PLANNING CONSULTATION RESPONSE

Application No	2026/0657
Proposal	Erection of 1no. building for industrial (class E(g)(iii)/B2) or storage and distribution (class B8) use with associated yard, parking, landform and landscaping (Reserved matters of the outline part of hybrid planning permission 2019/1573) for Unit 6 seeking approval of access, appearance, landscaping, layout and scale.
Address	Land to the north and south of Dearne Valley Parkway, Hoyland, Barnsley
Date of Consultation Reply	02/10/26
Consultee	Nik King, Senior Urban Design Officer

These are the design comments for planning application 2026/0657.

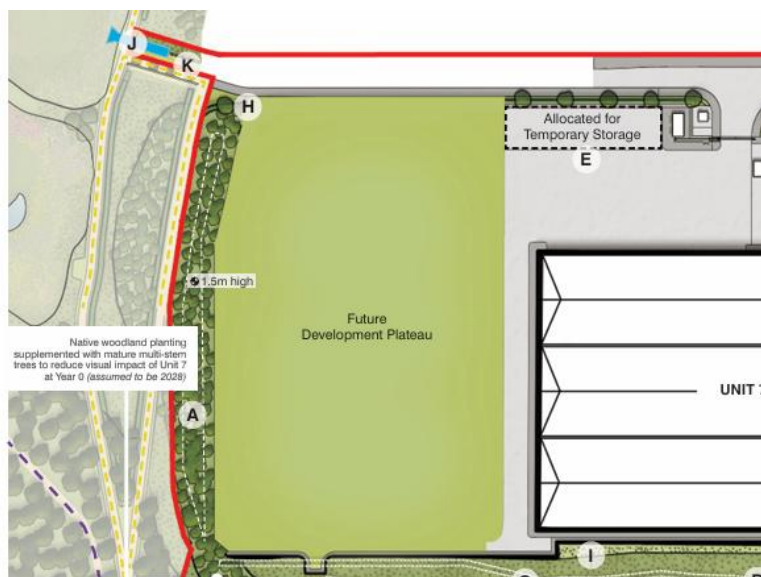
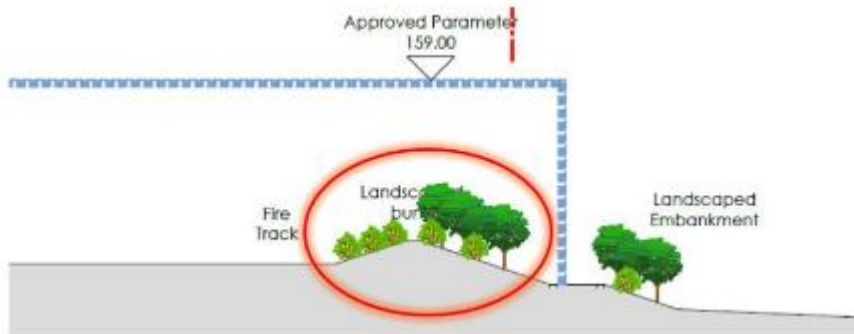
On a raised site such as this platform, in an ideal situation the car parking and service yards would be 'nestled' between the buildings, so that they do not go beyond the outer building lines on the outer edges of the site. Looking at the image on the plan on page 8 of the design and access statement, (shown below), such a situation has occurred on units 1, 2 and 3 as built.

Unit 4, (planning approved), looks like its front car park will be well nestled behind a wide band of tree planting from the adjacent road leading into the residential area of the masterplan.

Aerial CG of Phase 2 - in response to Condition 25(c) - 3D Aerial View

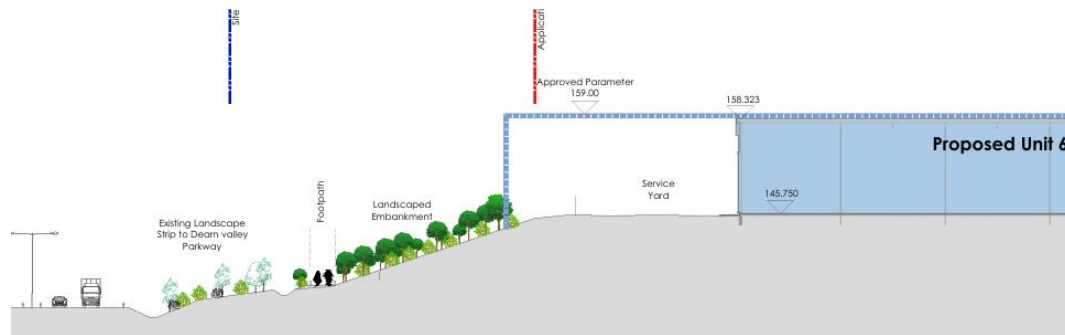
Regarding the planting on the slopes, I note that Page 11 of the design and access statement contains the following image:

However, when I drive along the Dearne Valley Parkway, whilst I note that some tree samplings were planted quite a while ago on the slopes to the north-west and south-west, I have to say that I don't think they are having any discernible visual impact.

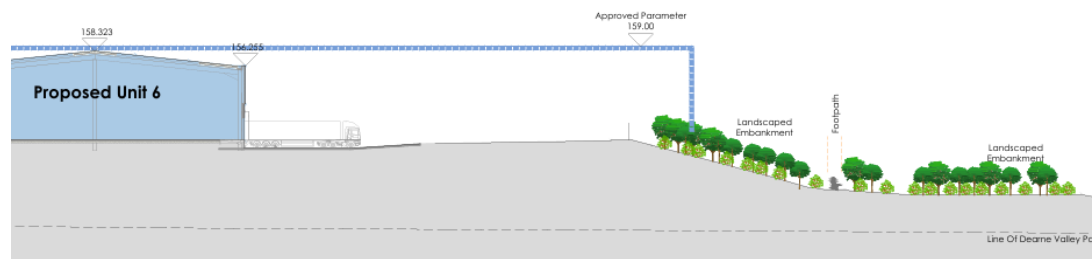
I don't think that tree coverage proposed on the level of the platform itself, (as part of this reserved matters application), or on the adjacent slopes, (from the outline application), would provide this level of screening.

The north-west slope by unit 6 is also shown on the drawing 'site section 1' (Rev PO1) as shown in the snapshot below:
